# Oil Sands Environmental Coalition

17 November 2016

**Re: The Shell Canada Energy Muskeg River Mine Fluid Tailings Management Plan OSCA Application No. 1870302**

**Figure 1: Expected Cumulative Tailings Under the TMF<sup>6</sup>**

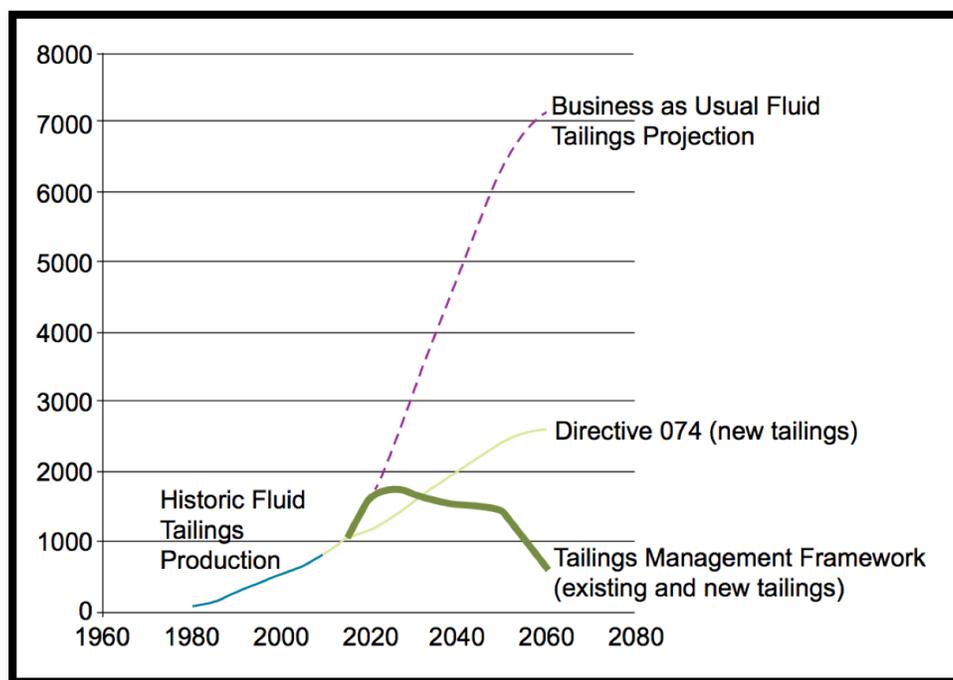
The TMF graphically outlines the expected cumulative trajectory of all fluid tailings on the landscape including a peak date for tailings accumulation, a rate of decline, and the point at which tailings cumulative tailings volumes will actually decline (**Figure 1**). OSEC has amalgamated the projected tailings volumes from all Directive 085 applications submitted to

**Figure 2:** Cumulative Tailings Volumes of All Directive 085 Applications Analyzed to Date

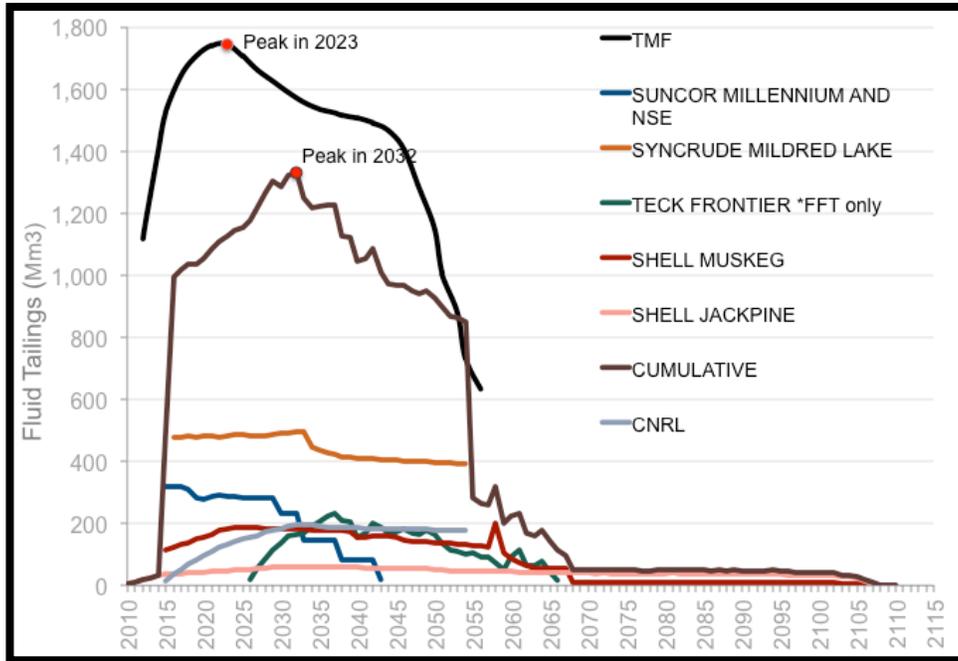
date, and compared it with the aforementioned TMF trajectory (**Figure 2**). This analysis has demonstrated a general trend wherein cumulative tailings volumes are peaking roughly ten years later than the TMF anticipated. This analysis is currently being expanded to include the projected fluid tailings volumes of all Alberta oilsands mines, as submitted for the November 1, 2016 deadline.

OSEC and the AER’s ability to determine the adequacy of Shell's plans are correspondingly dependent on an assessment that the sum of the approved tailings plans are consistent with the TMF's objectives. As such, it is essential for regulators and stakeholders to be able to compare all tailings plans in conjunction to ensure responsible regulatory decisions are made. We thereby strongly recommend that no applications be approved until all proponent plans have been submitted and reviewed.
